Access Compliance Report

Public Rights-of-Way

(Curb Ramps)

Intersection ID: 10033949	Main Street: PARK_RD	Cross Street: N/A	Location: NE
ADA ID: DC7C13C6A957	Ramp Type: BlendTrans2	Initial Pass/Fail: Fail	Overall Compliance: No
		Severity Score: 1.25

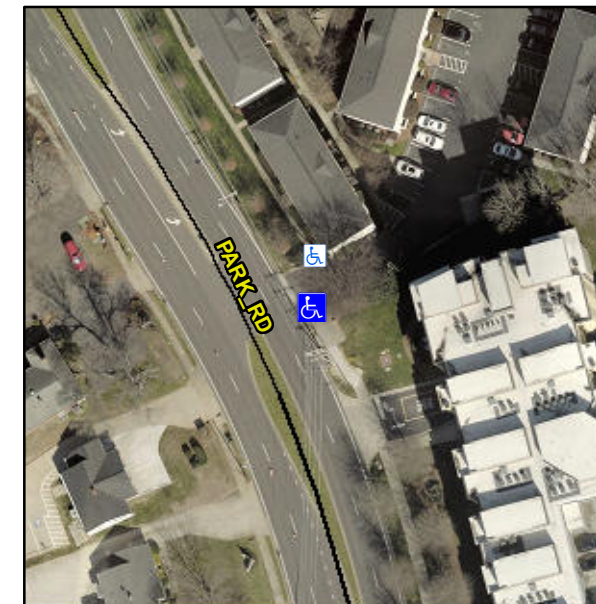
Compliance	Description	Data	Compliance	Description	Data
N/A	Ramp Length (in)	81.0	Yes	BlendTrans Slope (%)	0.5
Yes	Ramp Width (in)	72.0	No	BlendTrans XSlope (%)	3.7
N/A	Flare Type LT	N/A	N/A	Flare Type RT	N/A
N/A	Flare Slope LT (%)	N/A	N/A	Flare Slope RT (%)	N/A
N/A	Flare Traversable LT?	N/A	N/A	Flare Traversable RT?	N/A
N/A	Landing Length (in)	N/A	N/A	DWS Provided?	N/A
N/A	Landing Width (in)	N/A	N/A	DWS Contrast?	N/A
N/A	Landing Slope (%)	N/A	N/A	DWS Length (in)	N/A
N/A	Landing X Slope (%)	N/A	N/A	DWS Full Width?	N/A
N/A	Landing Curb? (Y/N)	N/A	N/A	DWS Offset (in)	N/A
N/A	Shared Landing?	N/A			
N/A	Gutter Ponding?	N/A	N/A	Gutter Slope (%)	N/A
N/A	Gutter Lip Ht (in)	N/A	N/A	Gutter X Slope (%)	N/A
N/A	Painted X Walk1?	No	N/A	Painted X Walk2?	N/A
	X Walk 1 Direction	To NE		X Walk 2 Direction	N/A
	X Walk 1 Width (in)	N/A		X Walk 2 Width (in)	N/A
	X Walk 1 Slope (%)	3.8		X Walk 2 Slope (%)	N/A
	X Walk 1 X Slope (%)	1.7		X Walk 2 X Slope (%)	N/A

Remove & Replace Curb Ramp With Two New Directional Ramps or Equivalent.
